Work Order ID 88432

DART AEROSPACE LTD		Work Order:	88432
Description: Crosstube High Fwd (205/212/412)		Part Number:	D212-664-101
Inspection Dwg: D212-664-141 Rev: D		Page 1 of 1

DRAWING NO. D212-664-141	TITLE XTUBE ASSY (205/212/412 HI FWD)	REV. D	DART AEROSPACE LTD ENGINEERING ORDER		D.E.O. NO. D212-664-141-D-1	SHEET NO. SHEET 1 OF 2	SCALE NTS
DRAWN	CHECKED	MFG. APPR.	APPROVED	DE APPR.			
DATE 11.04.07	DATE 11.04.11	DATE 11.04.12	DATE 11/04/12	DATE 11.04.12

ADD AN INSPECTION WINDOW TO UNDERSIDE OF CROSSTUBE.

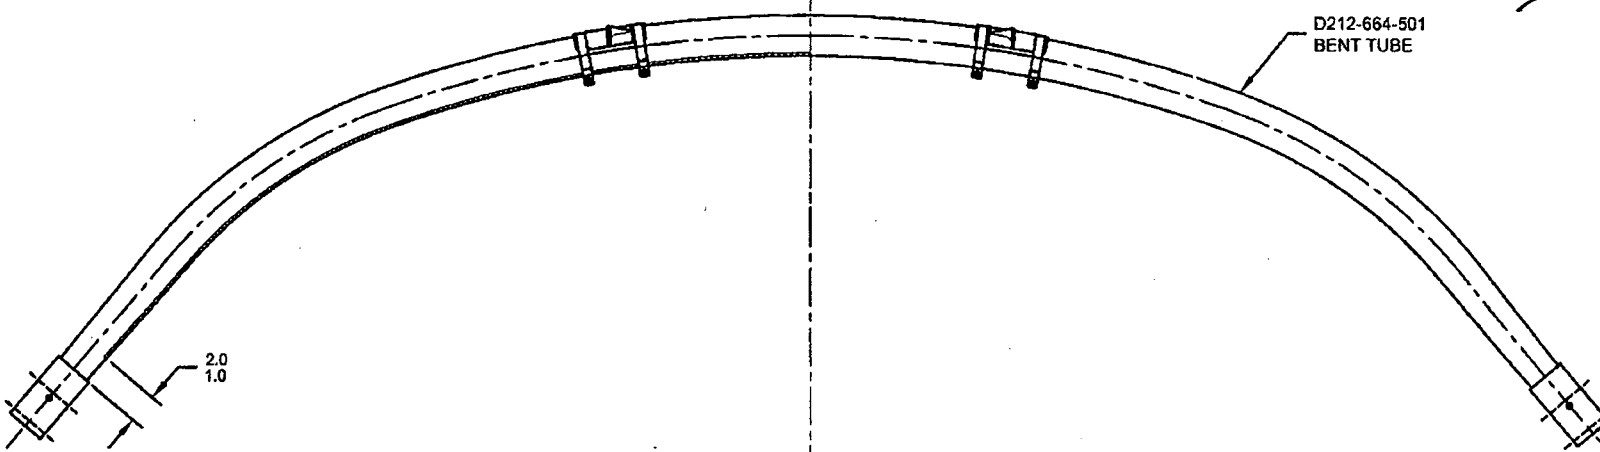
NOTES 2 OF SHEET 1 IS AMENDED AS FOLLOWS:

MASK AREA PRIOR TO PAINTING,
REMOVE MASKING AFTER PAINT
AND APPLY CLEAR COAT

- 2) FINISH: CHEMICAL CONVERSION COAT PER DART QSI 005 4.1
PRIME INSIDE AND OUTSIDE PER DART QSI 005 4.2
MASK UNDERSIDE OF CROSSTUBE AS SHOWN (HATCHED AREA) AND
PAINT OUTSIDE PER DART QSI 005 4.2
REMOVE MASKING AND APPLY CLEAR COAT
